# ORIGINATION FORM

Proposed Revisions to a Standard Plans Index  
(Please provide all information – Incomplete forms will be returned)

Index Number: 430-021  
Sheet Number (s): 1 of 1  
Index Title: Cross Drain Mitered End Section

Index Reorganized. General Notes and Slope And Ditch Transitions moved to Sheet 1. Design Notes Deleted, can be found in the Drainage Manual. Sod requirements and information moved to Specifications.  
Sheet 2: Combined details for Round and Elliptical Concrete Pipe.  
Sheet 3: Combined Tables of Quantities for Round and Elliptical Concrete Pipe.  
Sheet 4: Combined details for Arched and Round Corrugated Metal Pipe.  
Sheet 5: Combined Tables of Quantities for Arched and Round Corrugated Metal Pipe.

**DESIGN NOTES**

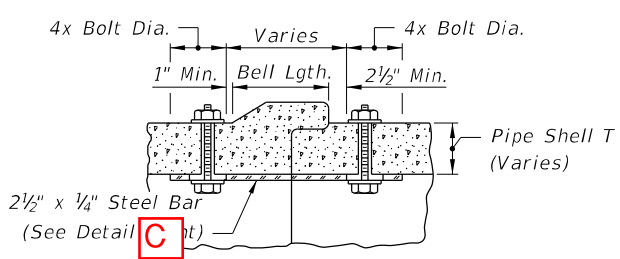
Delete; in Drainage Manual

Design Note (Moved to Drainage Manual)

**"DETAIL 'C'"**

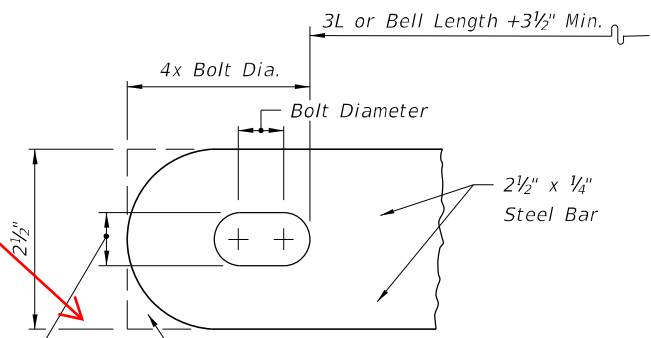
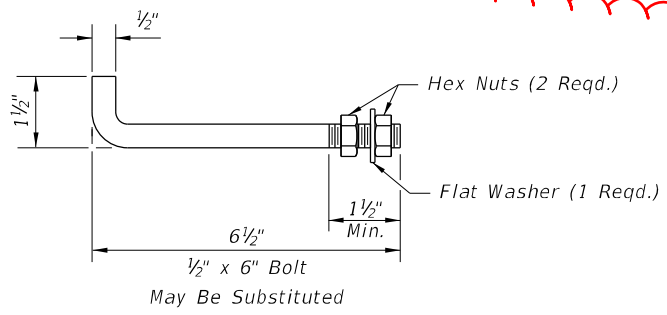
Numbered, Reworded, and Added Notes

Changed to Sheet 1 of 6

Created Table

Enlarged for clarity

**Dimensions and Quantities for Round Concrete Pipe**

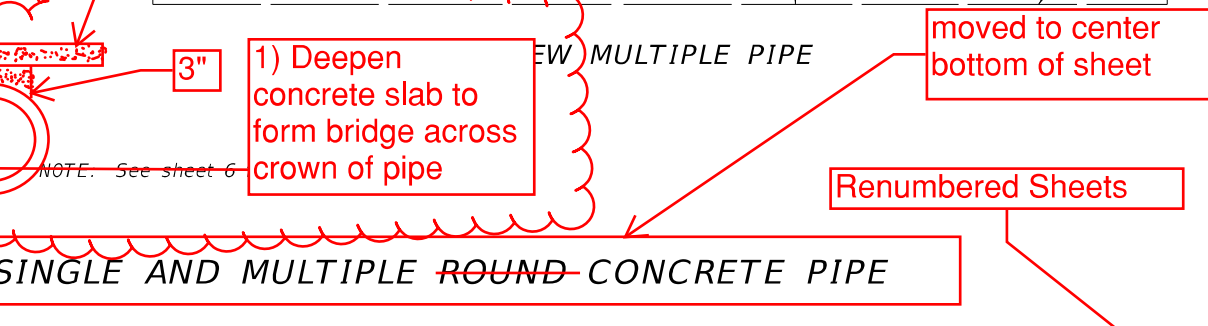
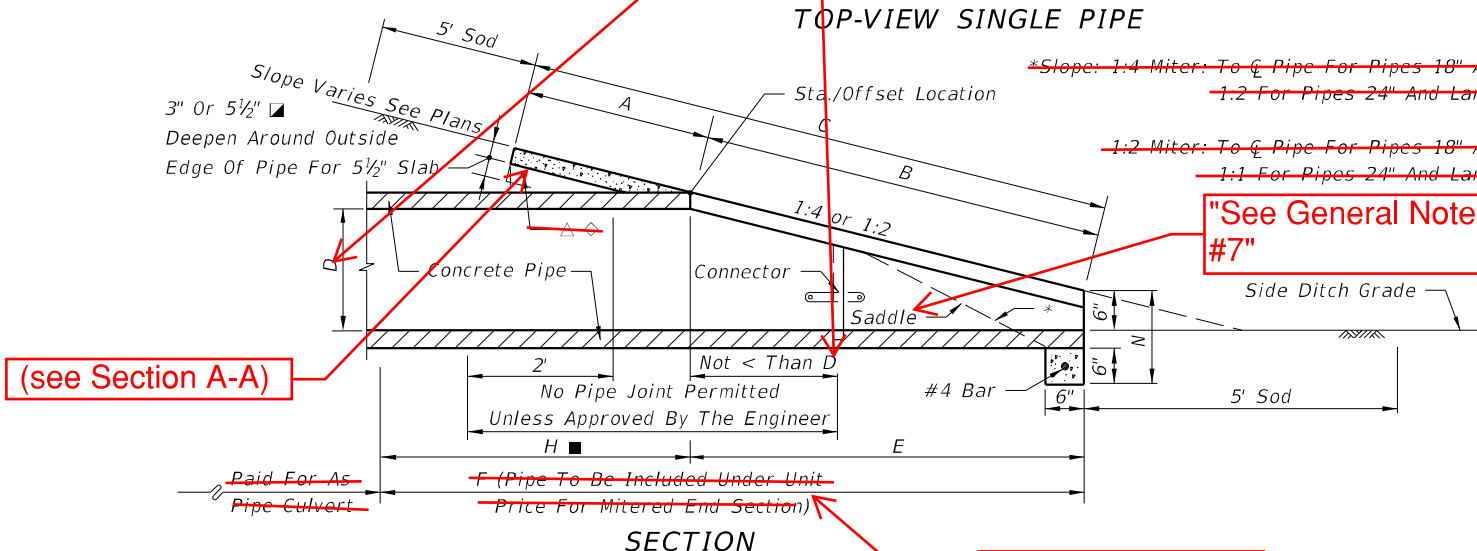
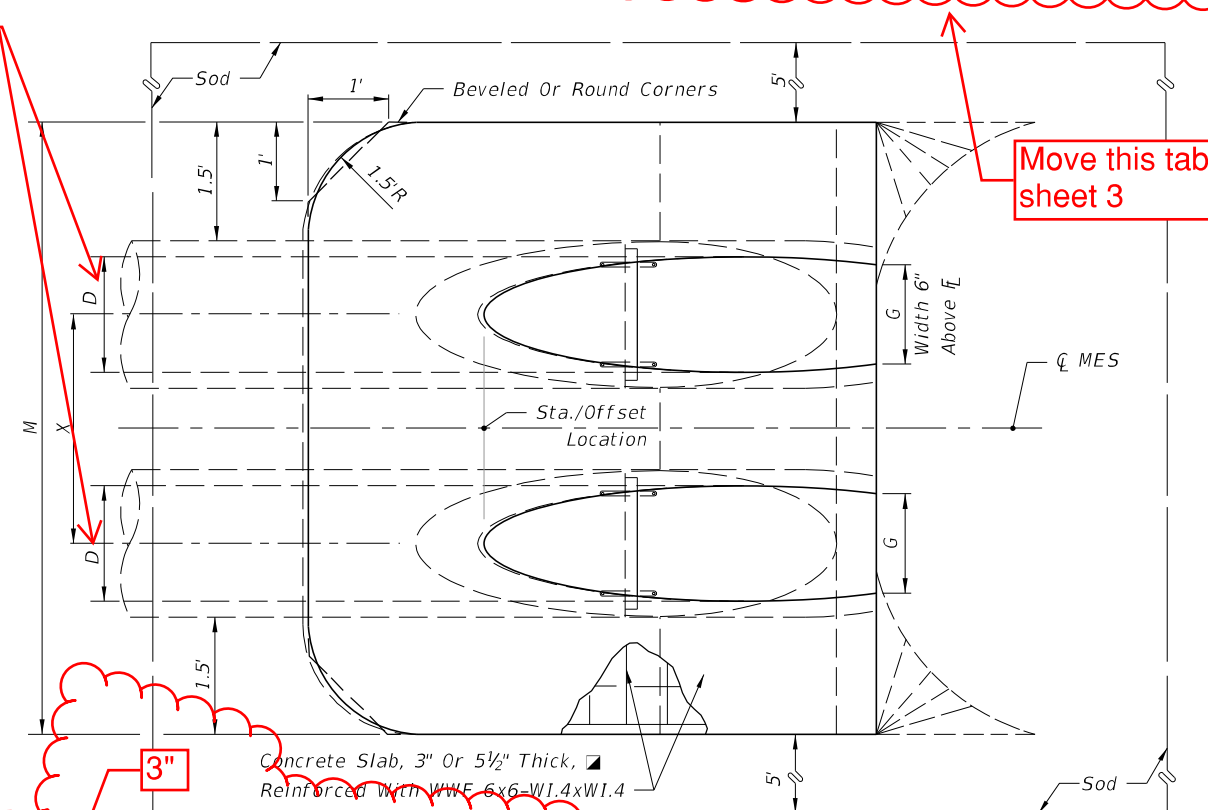
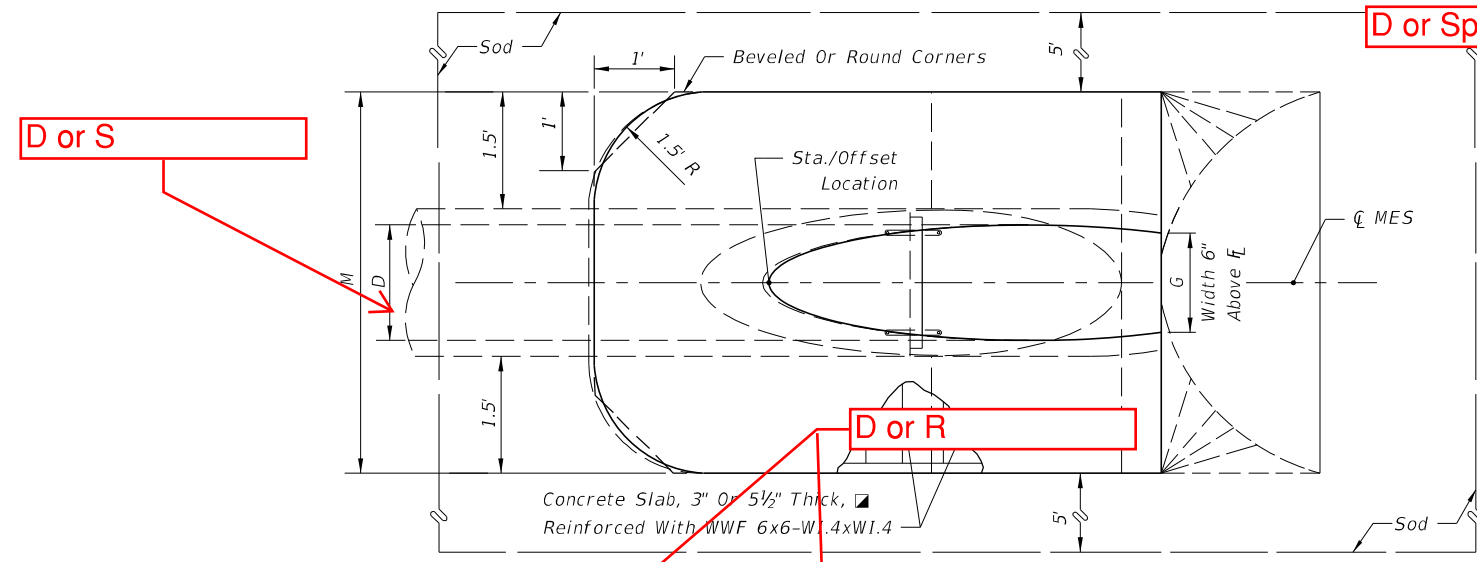
Moved to SHEET 3

Move this table to sheet 3

"See General Note #7"

1) Deepen concrete slab to form bridge across crown of pipe

moved to center bottom of sheet

Renumbered Sheets

TOP VIEW-SINGLE PIPE

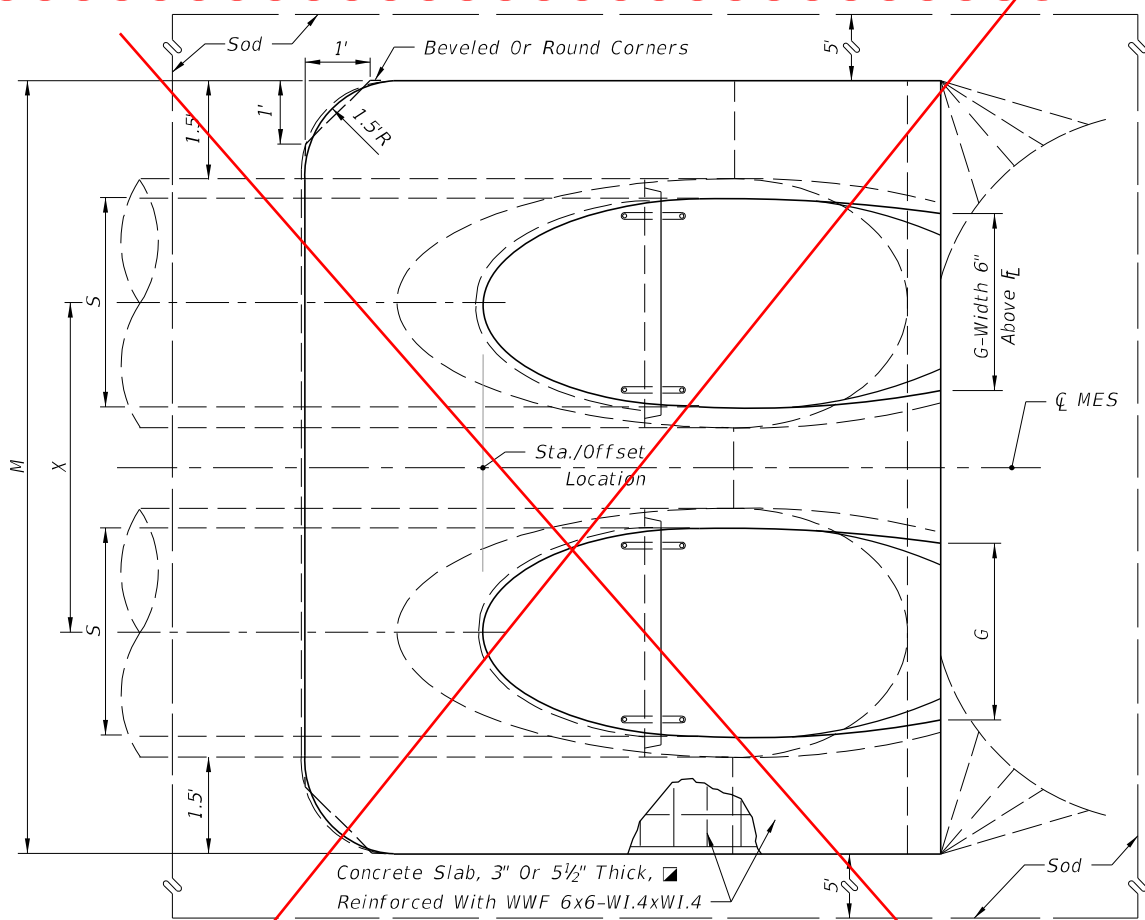
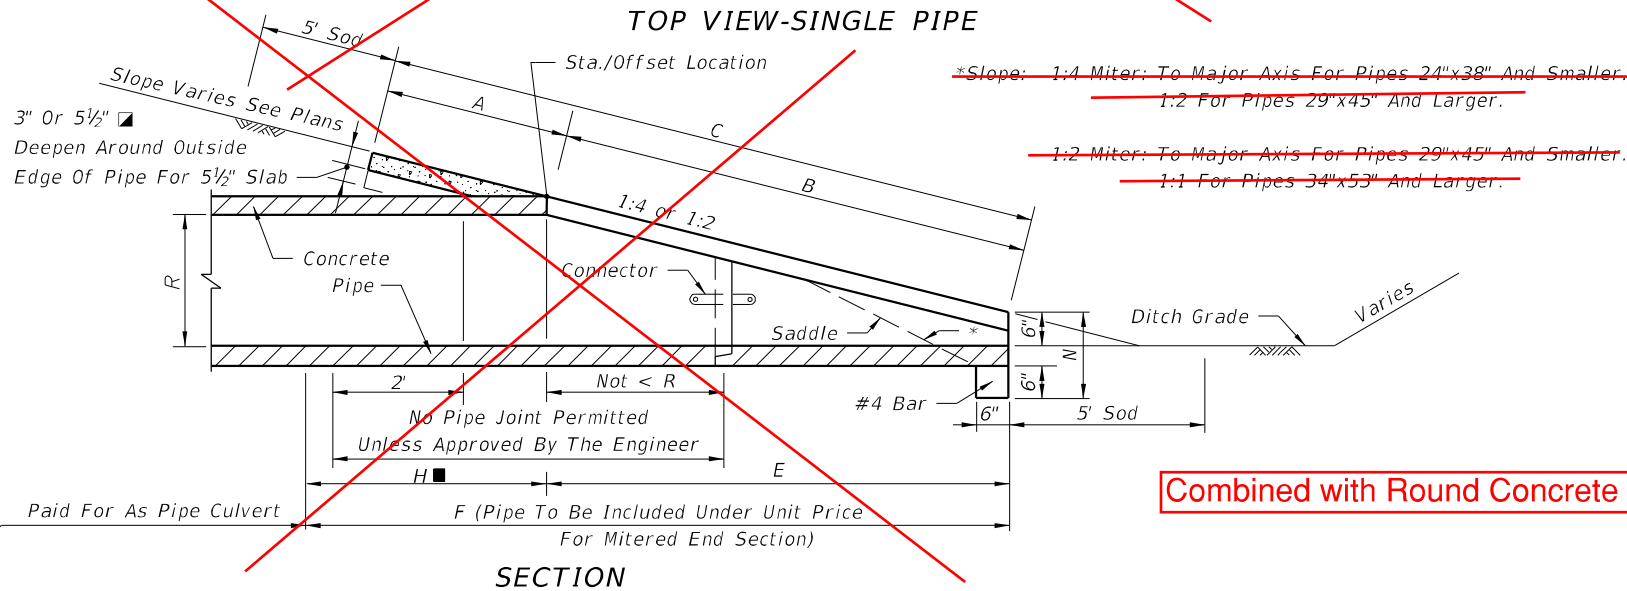
Moved to SHEET 3

Combined with Round Concrete Pipe Details

Renumbered Sheets

**SINGLE AND MULTIPLE ROUND CORRUGATED METAL PIPE**

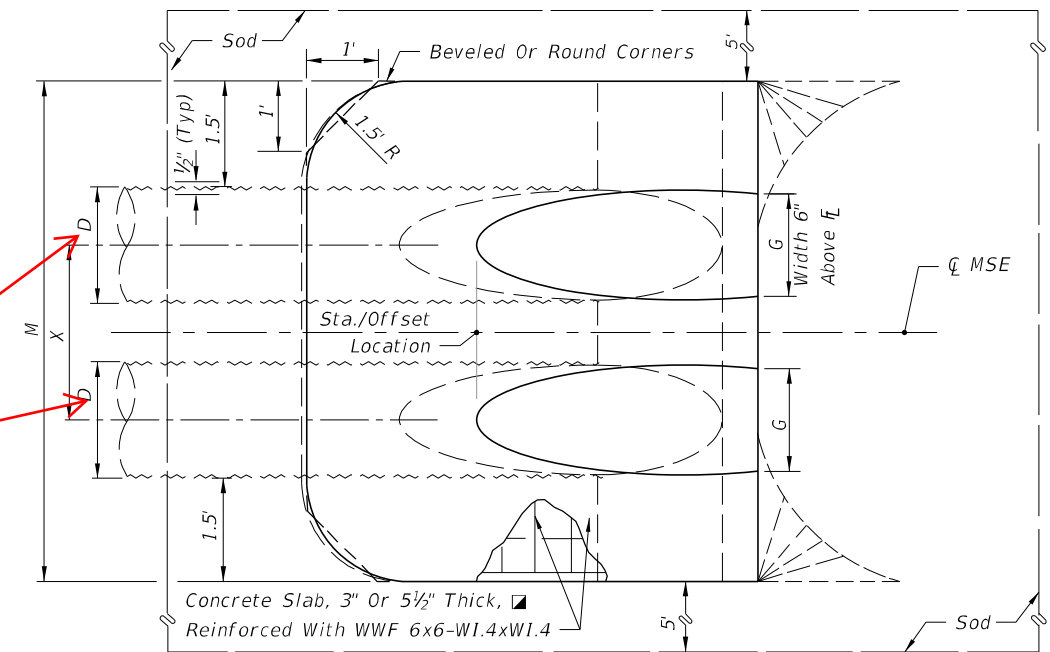
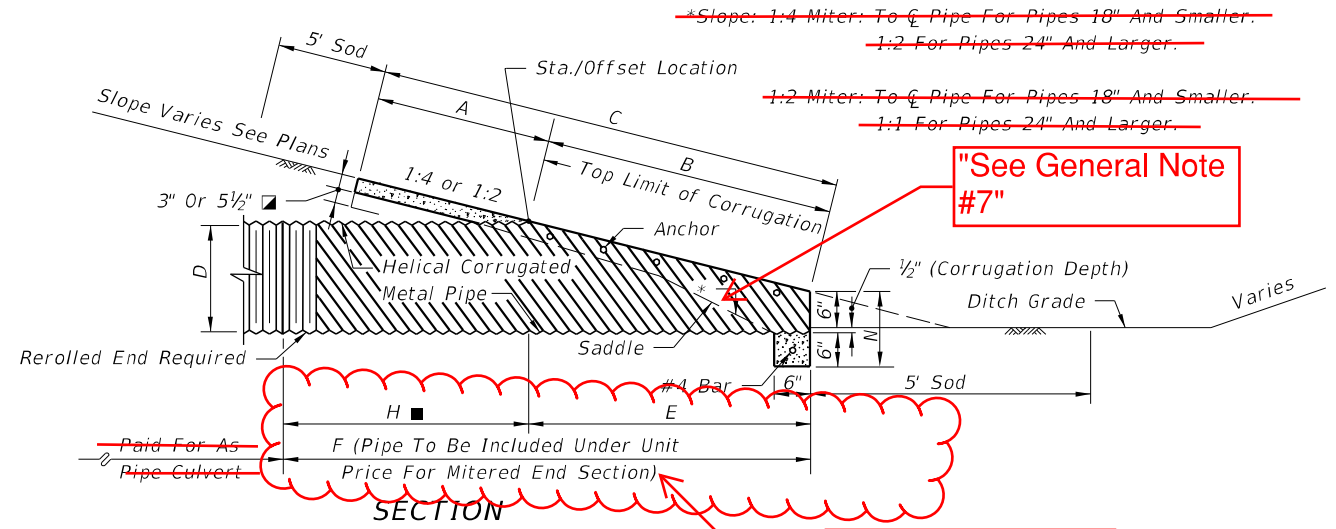
**Moved to SHEET 5**

**Moved to center bottom of sheet**

**Replace text with "F(Pipe included in Mitered End Section)"**

~~NOTE: See Sheet 6 For Details And Notes.~~

**Renumbered Sheets**

~~SINGLE AND MULTIPLE CORRUGATED METAL PIPE-ARCH~~

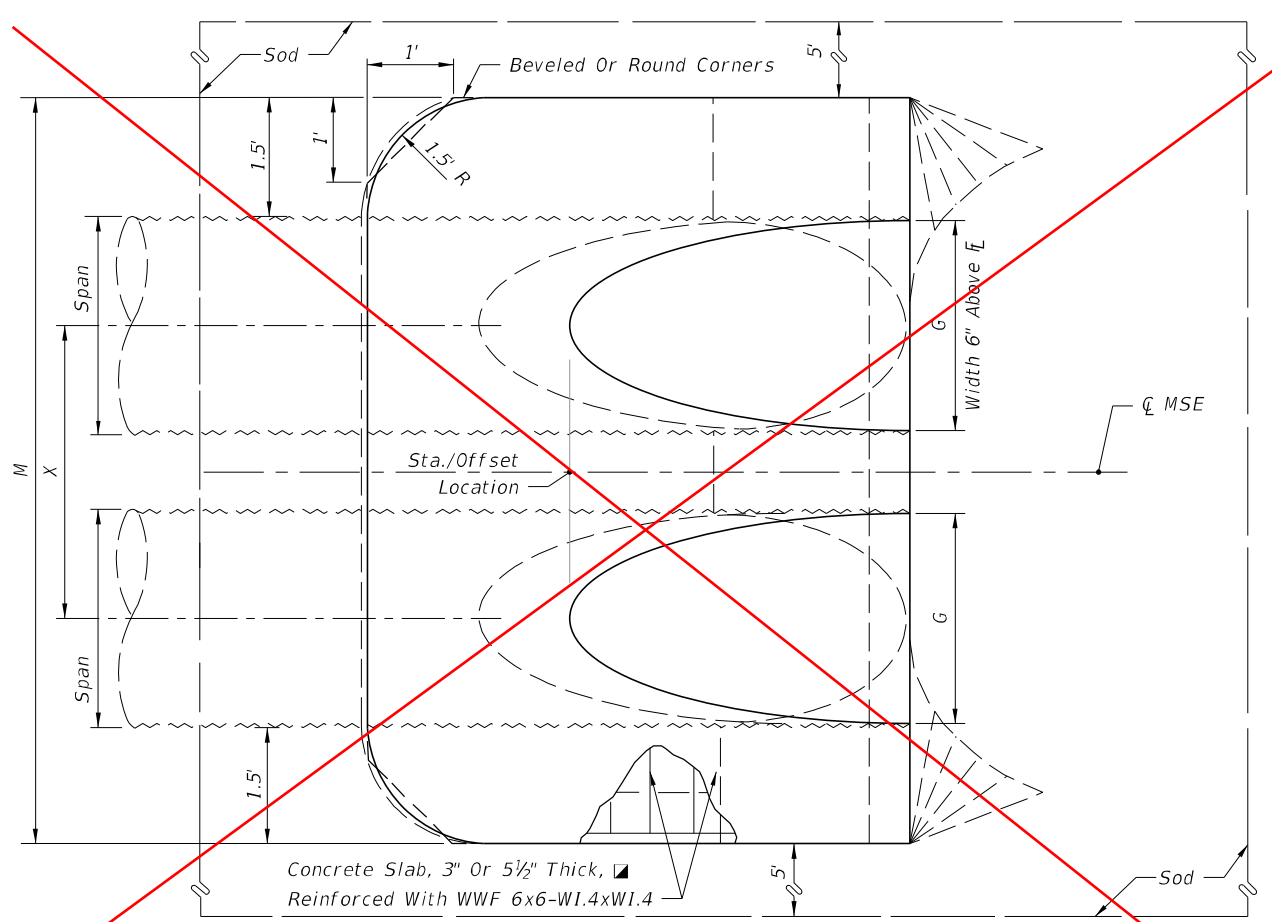
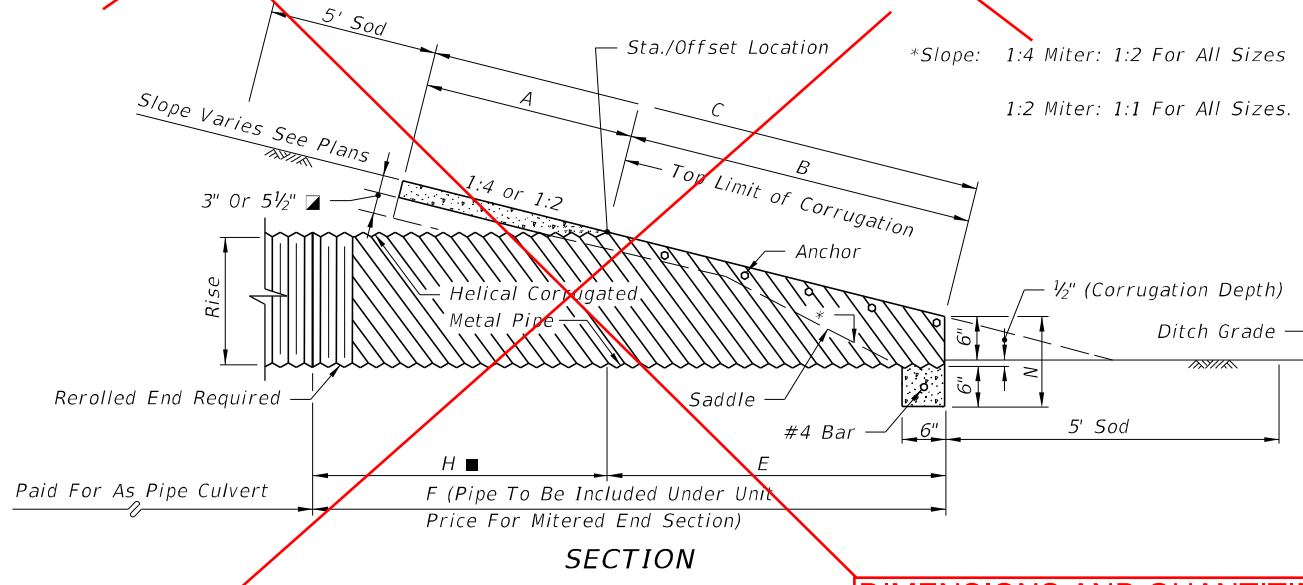
Renumbered Sheets

QUANTITIES FOR 3" THICK CONCRETE SLABS (CY)

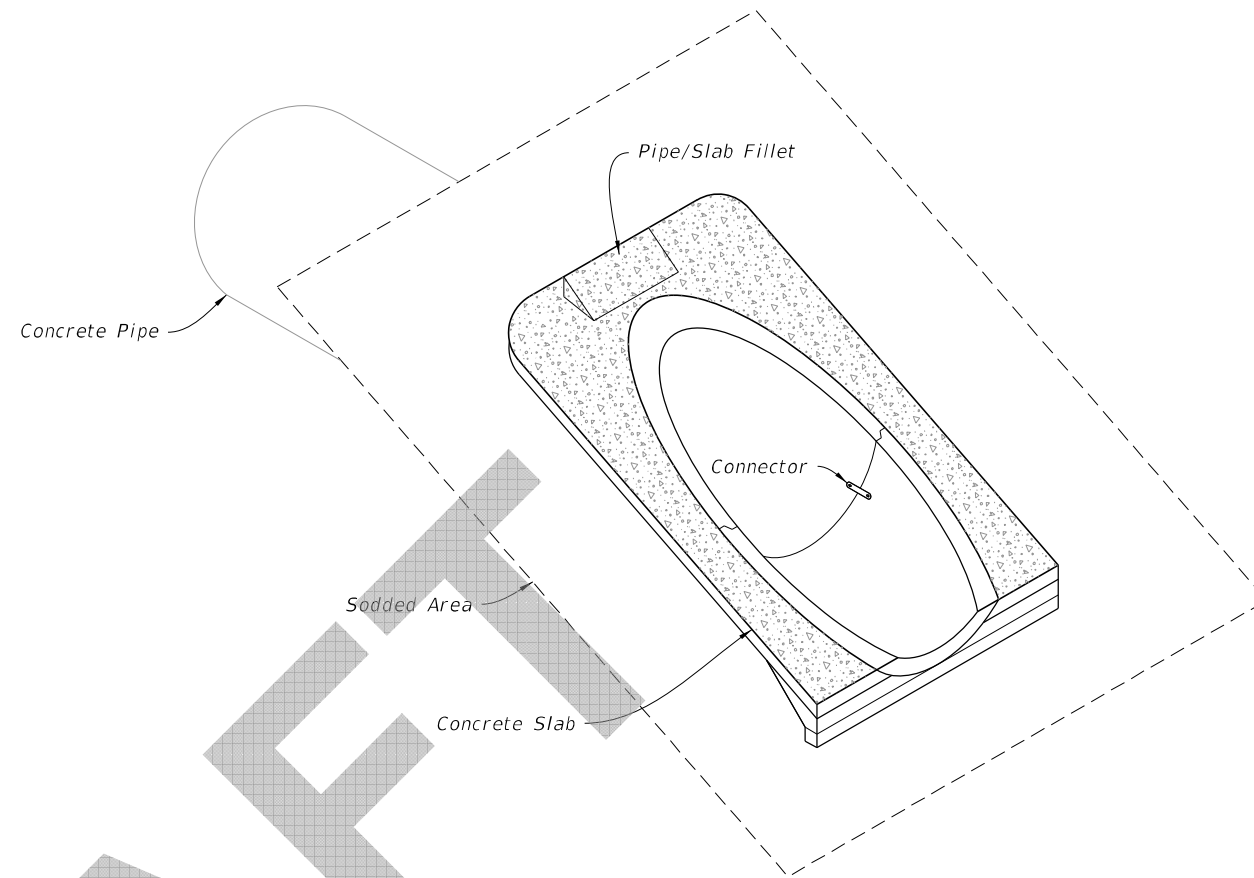
Added to appropriate tables on Sheets 2-5
